MODIFICATION ON DLE30

STEP 1

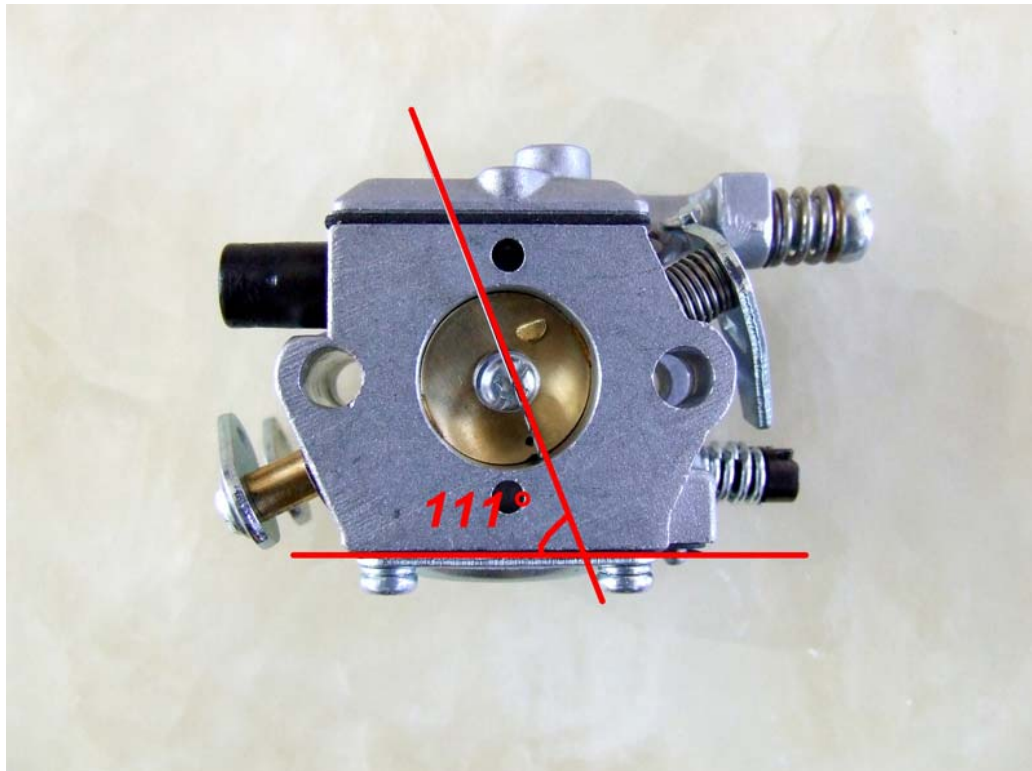
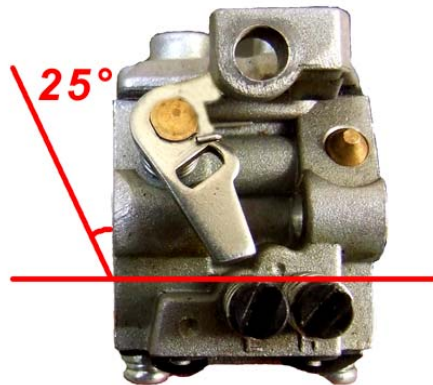
Reduce the compression ratio of cylinder by adding 2 cylinder gaskets. The thickness of cylinder gasket was 0.5mm, please be sure the thickness of gasket reaches to 1-1.5mm if you have to use something substituted.
